PŘÍKAZ K ZACHOVÁNÍ LETOVÉ ZPŮSOBILOSTI

CAA-AD-T-115/2001

VRTULNÍK - SILOVÝ UZEL PŘÍHRADOVÉ KONSTRUKCE DRAKU – KONTROLA/VÝMĚNA

2001-25-52 SCHWEIZER AIRCRAFT CORPORATION: Docket No. 2001-SW-58-AD. Supersedes 76-18-01, Amendment No. 39-2707, Docket No. 72-WE-23-AD.

Figure 1

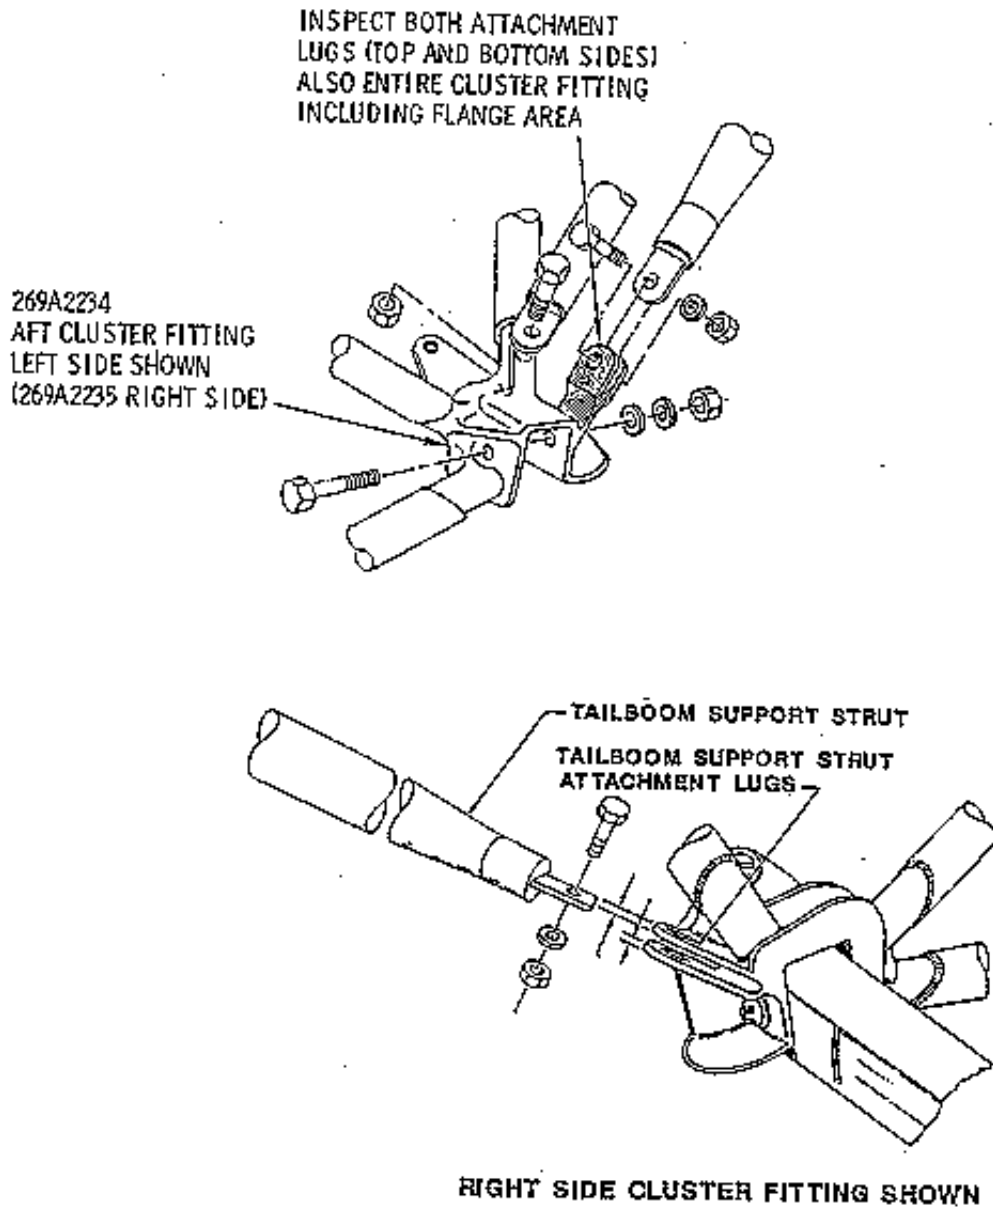
(2) Dye-penetrant inspect the lugs on each aft cluster fitting. See Figure 1.

(3) If a crack is found, before further flight, replace the cracked cluster fitting with an airworthy cluster fitting. Cluster

fittings, P/N 269A2234 and 269A2235, are not eligible to replace a cracked cluster fitting.
